# HERITAGE IMPACT ASSESSMENT

## 267 O'CONNOR STREET, OTTAWA

Prepare By: John Stewart, Commonwealth Historic Resource Management  
4th Revision, December 2025

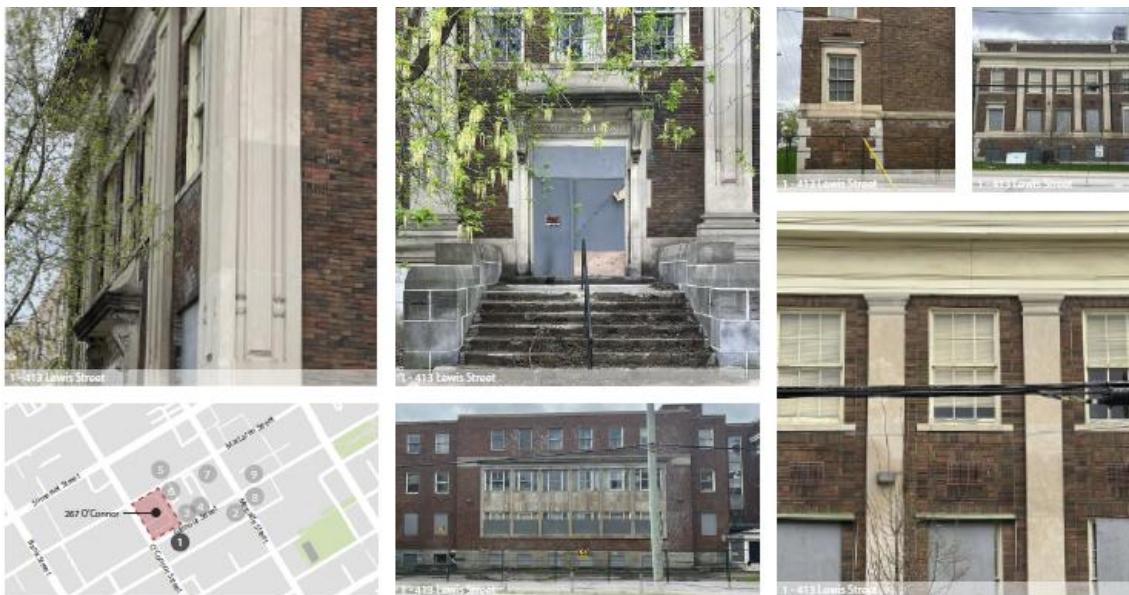
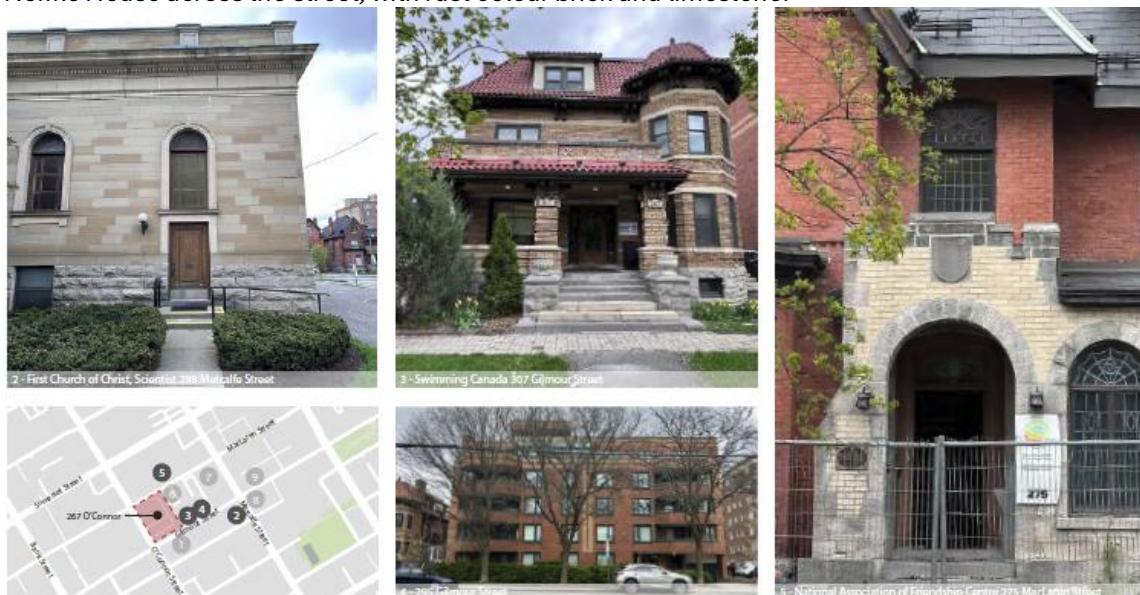
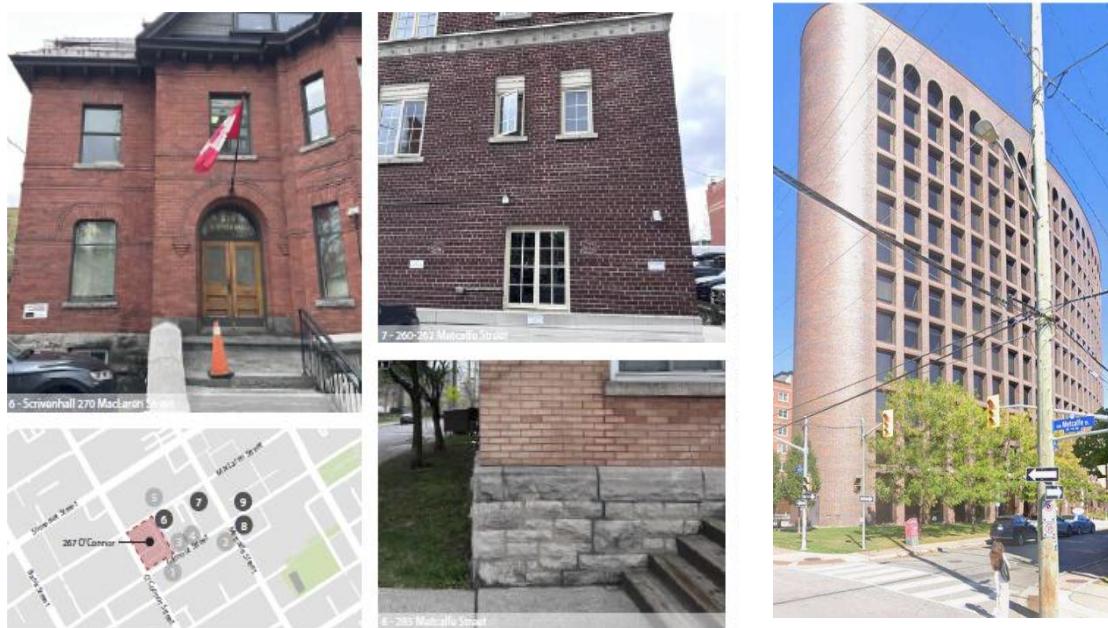
5. The HCD Plan states that proposals for a landmark building should focus on integration and compatibility with the surrounding HCD for the lowerfloors/base of the building. The podium for the proposal must be more compatible with the existing character of the Centretown HCD. The examples currently being used for design inspiration are not in the Centretown HCD and/or have been demolished.

**Response: Please reference Figures 3, 4, and 5. These examples are all from the neighbourhood buildings, focusing on the blocks between O'Connor (west) Metcalfe (east), MacLaren (north), and Gilmour (south.)**
